METROPOLITAN AREA PLANNING
DEPARTMENT

Re: Administrative Adjustment 99-7: Administrative Adjustment to reduce the number of required parking spaces from 121 to 110 and allow parking within the front yard setback on property zoned "TF-3" Two-Family and generally located south of 21st Street North and west of Carmen Drive.

STAFF REPORT

CASE NUMBER: CU-507

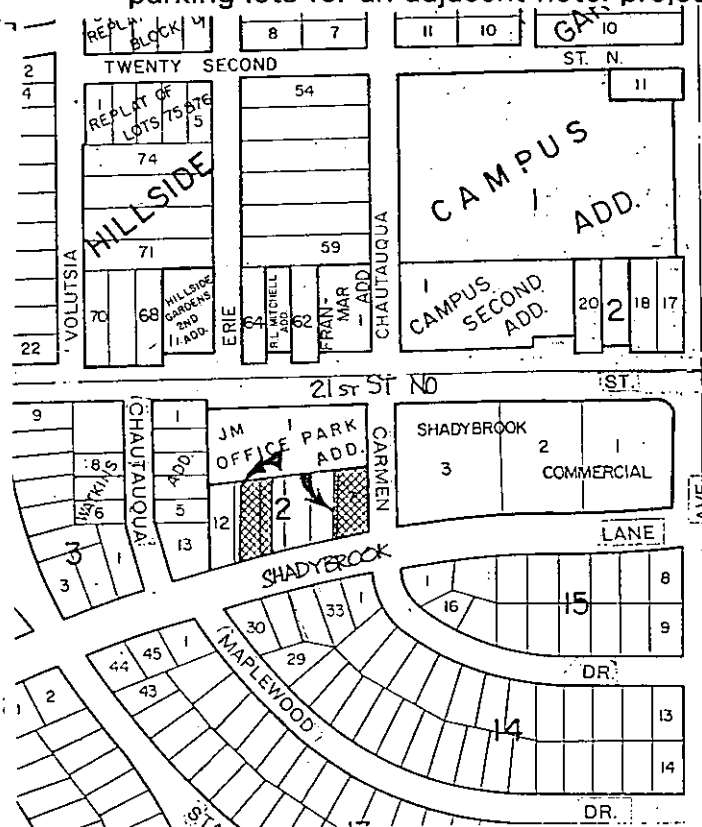
The developer is required to provide 121 parking spaces for the hotel project based on the Unified Zoning Code requirements of providing one parking space per guest room plus one parking space per 250 square feet of retail, service and office space and one parking space per 5 occupants allowed in a restaurant contained within the hotel. The amount of parking required can be reduced by administrative adjustment for commercial projects and would result in a minimum number of required parking spaces of 109 with the granting of an administrative adjustment. The attached site plan shows 110 parking spaces, with 57 of these spaces located on "TF-3" zoned property.

This request for a Conditional Use for ancillary parking is related to three additional requests. As mentioned, an administrative adjustment is needed to reduce total parking spaces required, and the administrative adjustment also should include a request to allow 5 of the spaces to be located within the front yard setback. Secondly, a variance of the "compatibility" standards to allow a total height of the hotel at 57 feet adjoining the lots to the south is being heard by the Board of Zoning Appeals. Finally, V-2156 requests vacation of the platted front yard setback from 25 feet to 12 feet to allow the canopy entrance of the hotel to extend into the required front yard setback along 21st Street.

RECOMMENDATION: Based upon information available prior to the public hearing, planning staff recommends that the request be APPROVED with the following conditions:

1. The applicant shall submit for approval ^{to the Planning Director} ~~by the Office of Central Inspection~~ a landscaping plan that shows the manner in which the total site (hotel site and ancillary parking) conforms with street yard landscaping, buffering, and parking lot landscaping and screening requirements of the Landscape Ordinance. As part of this landscaping plan, the applicant will place a fence six to eight feet in height along the perimeter of the parking lot areas adjoining "TF-3" Two-Family property located west and south of the property, except that this may be modified by the landscape plan in order to meet traffic visibility requirements.

2. Access to the ancillary parking lots shall be north onto the drive circulating around the rear of the hotel and onto Carmen Drive or 21st Street North. No openings shall be along Shadybrook Drive.
3. The site will be developed in substantial conformance with an approved site plan. Any violation of the above stated conditions shall render this "Conditional Use" permit null and void.

ARCHITECTURAL SITE PLAN
SCALE: 1" = 20'-0"
FILE: 21CRSITI

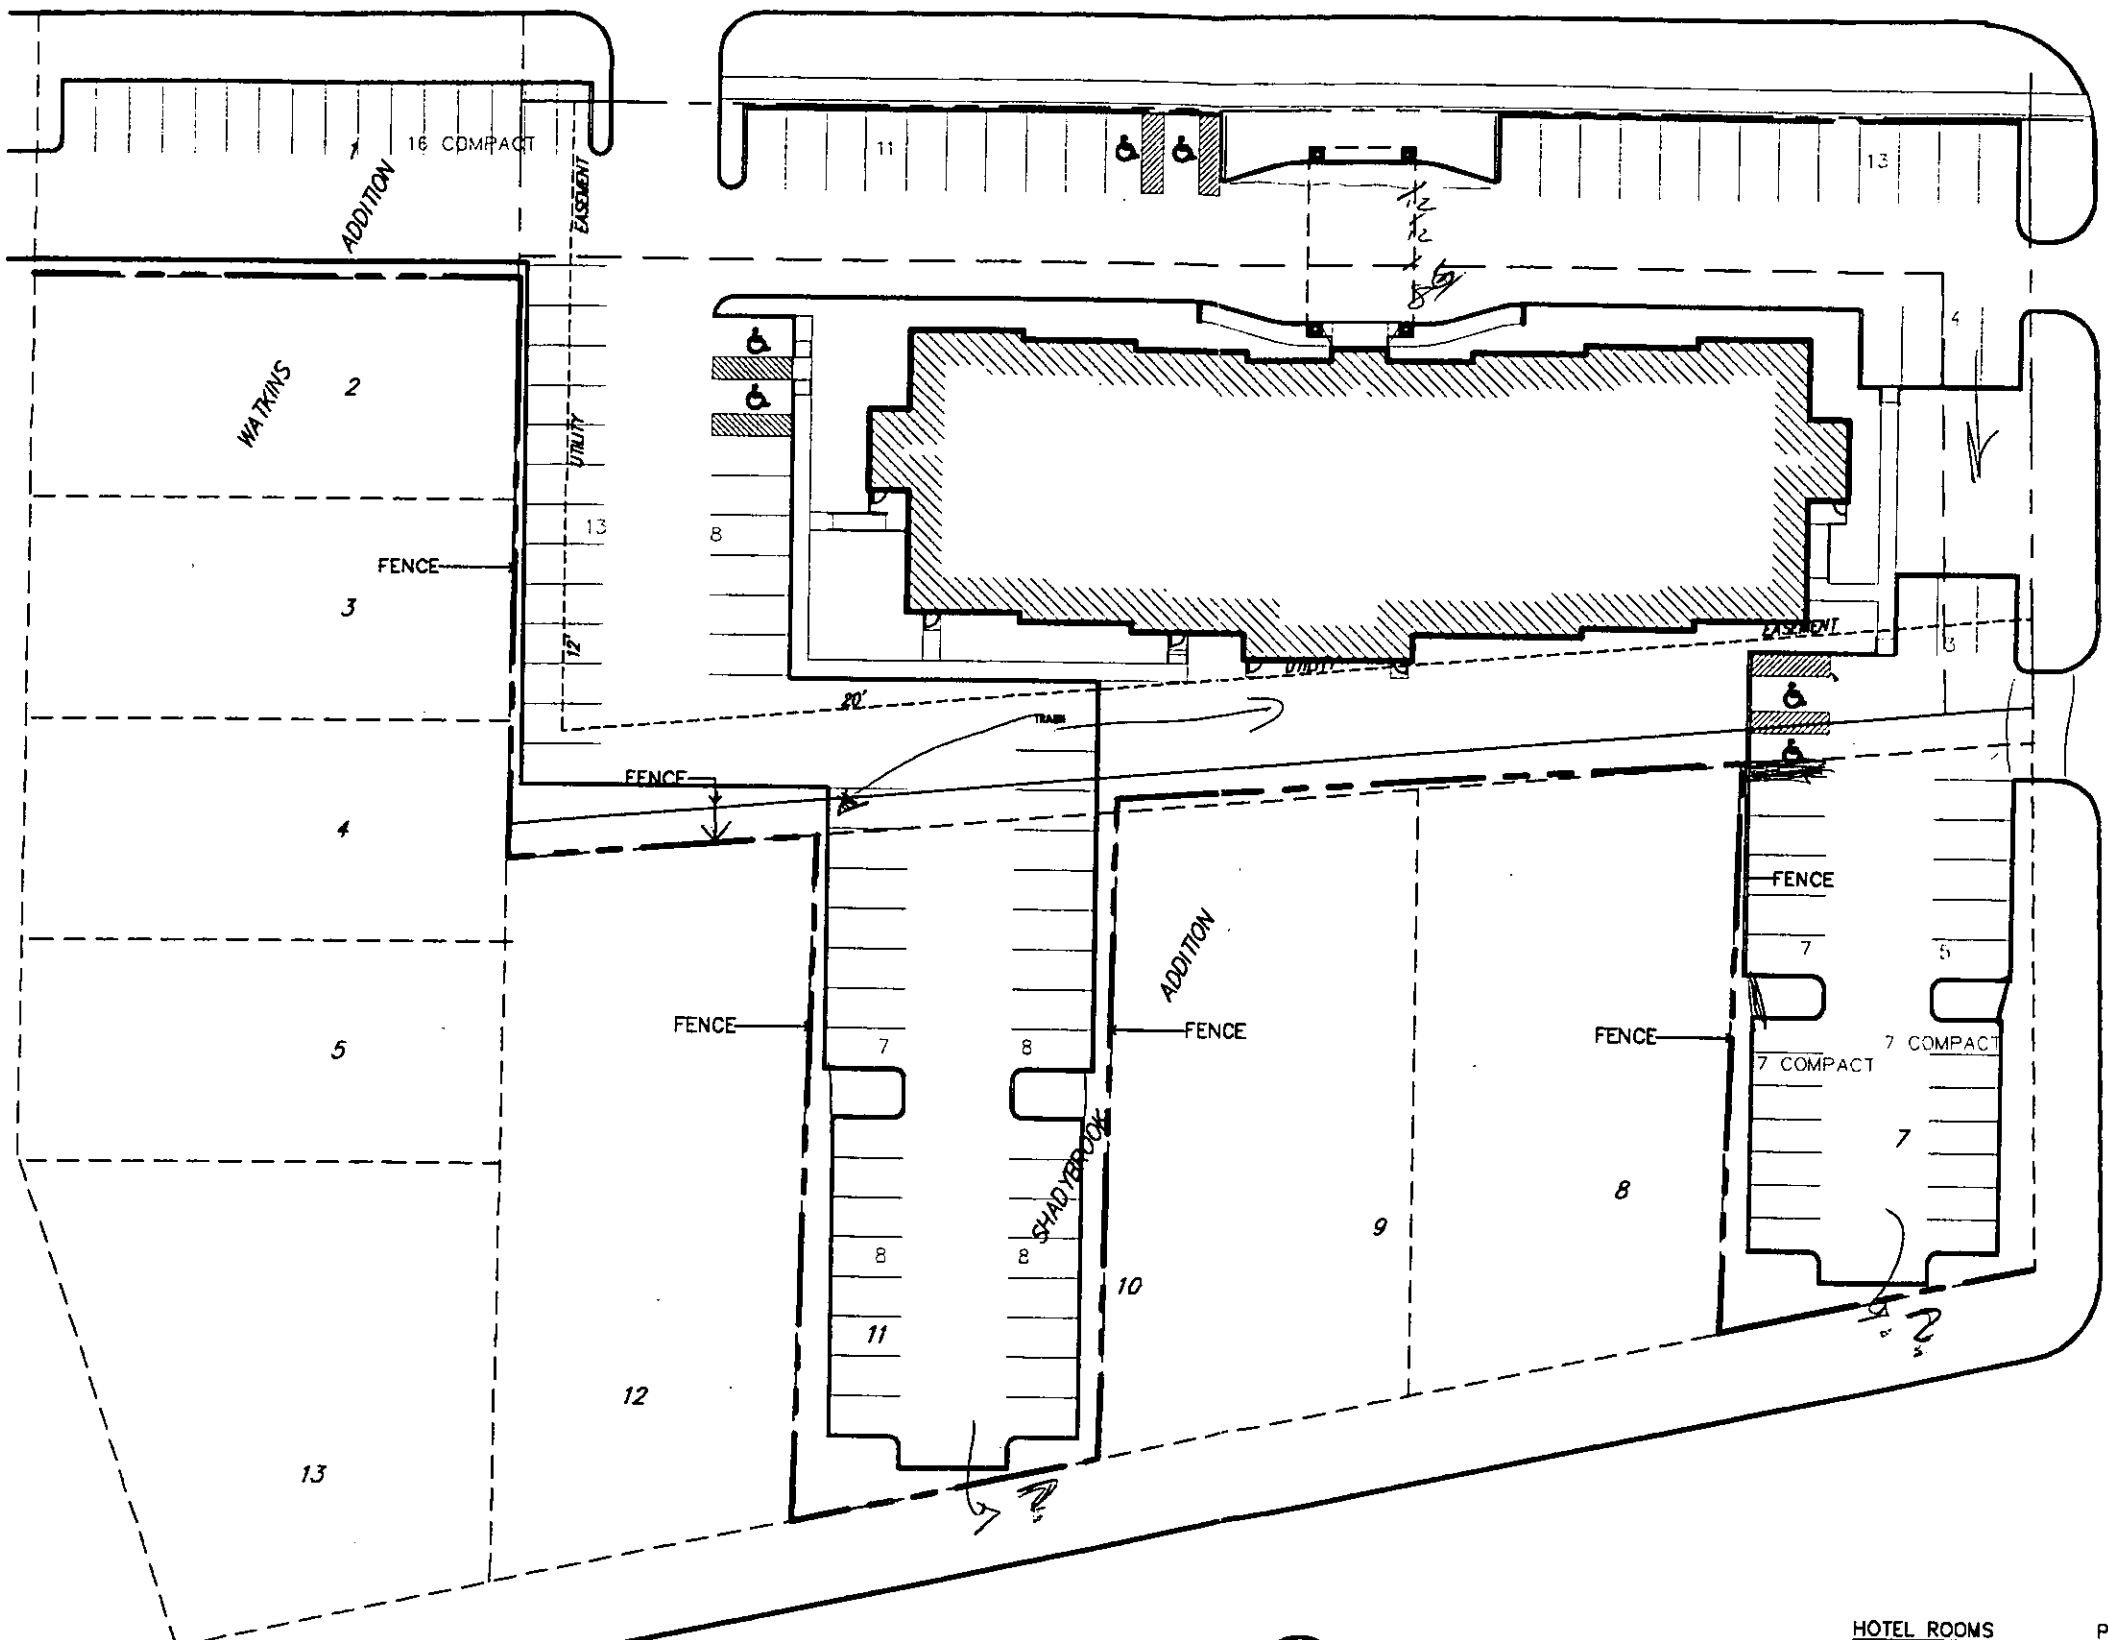
Leonard Wesley - negative impact upon his duplex

Arthur Bryant / Clarence Clark: hotel generate • noise

- traffic
- increased fighting
- Δ residential character
- interrupted sleep due to hotel patrons

Lighting - Code requirements

Crawford Lighting } spill over lighting will be reduced by fence; $\frac{1}{2}$ distance from neighboring lot unless shielded to be away from residential use

Consider: Fence - not a wall

Sum: Ht. not to exceed, li not higher than max 16' effect in straight
